City of Tucker

Land Use Petition: SLUP-24-0004 and CV-24-0006

Planning Commission: September 19, 2024

PROJECT LOCATION:	4419 Cowan Road
APPLICATION NUMBERS:	SLUP-24-0004 and CV-24-0006
DISTRICT/LANDLOT(S):	Land District 18, Land Lot 214
ACREAGE:	1.53 acres
EXISTING ZONING	DT-2 (Downtown Corridor Zone)
EXISTING LAND USE	Downtown
FUTURE LAND USE MAP DESIGNATION:	Downtown
OVERLAY DISTRICT:	N/A
APPLICANT:	Kevin Maher, Placemaker Design
OWNER:	E. Cowan Properties, LLC
PROPOSED DEVELOPMENT:	Special Land Use Permit to allow a multi-family use adjacent to a residential zoning district (office to multifamily conversion)
STAFF RECOMMENDATION:	Approval with conditions of SLUP-24-0004 and CV-24-0006

Figure 1. Proposed front elevation facing internal drive aisle. Stucco siding.

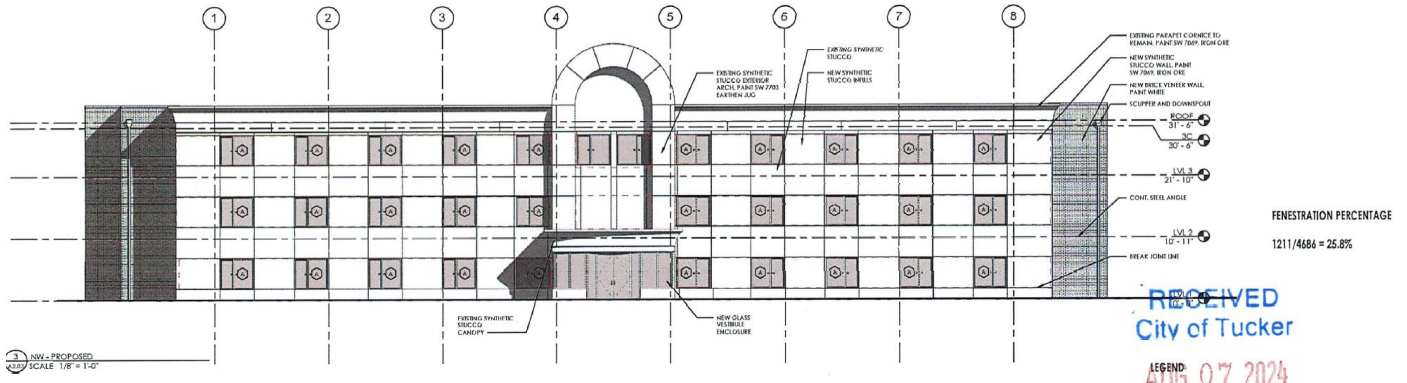
Code Section 46-990(d)(1) requires that “facades must be faced in brick, natural or synthetic stone, or painted wood/cementitious clapboard” and that “Facades may not be faced in aluminum, metal, corrugated steel, vinyl or plastic, plywood, pressed wood, imitation wood, EIFS, true or synthetic stucco, or concrete masonry units.” This requirement is intended to create aesthetically appealing facades that improve the pedestrian experience in the Downtown areas. Because this project is the redevelopment

of an existing building with a stucco façade, the applicants are requesting relief from the materials requirement so that they can use additional stucco when they fill in some of the large office windows to create a more residential appearance to the structure.

A concurrent variance is requested to allow the use of additional stucco material on the exterior elevations.

3. The use of stucco shall be permitted on the west and east facades (CV-24-0006).
4. The minimum lease term shall not be shorter than 6 months.
5. An on-site leasing office with property maintenance staff shall be provided for the multifamily units to serve as a contact point for residents and local authorities.

Figure 2. Cowan Road elevation, faced with brick, not stucco. Staff recommends a canopy over the door and additional glazing around the door.

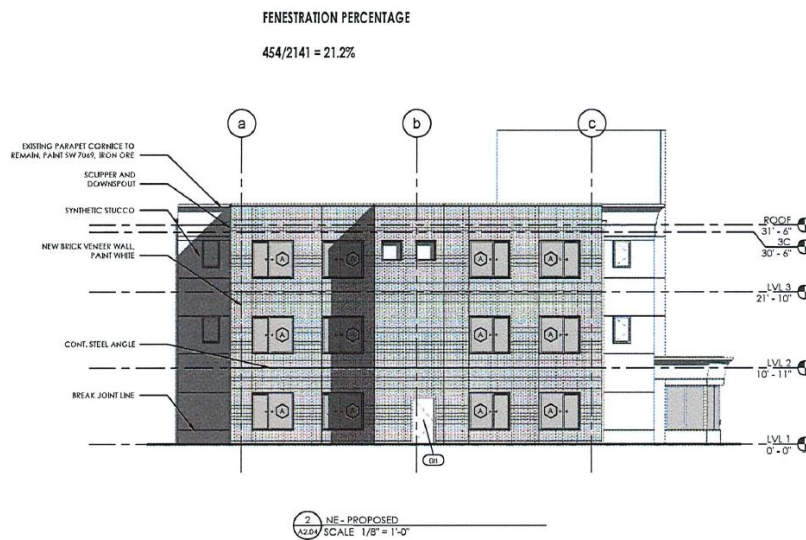
New buildings in the Downtown zoning districts that are adjacent to public streets require a primary pedestrian entrance facing the street in order to promote active storefronts and walkability. The primary pedestrian entrance on this office building faces the interior drive aisle. The building elevation that faces Cowan Road contains only a plain service door. The staff recommends updating the Cowan Road elevation to meet the spirit of the regulation, such as a flat canopy over the door and more glazing in the door surround.

8. The Owner/Developer shall enhance the northeastern façade facing Cowan Road to comply with the pedestrian entrance standards of the Downtown zoning districts by adding a metal canopy over the service door, as well as additional glazing around the door.
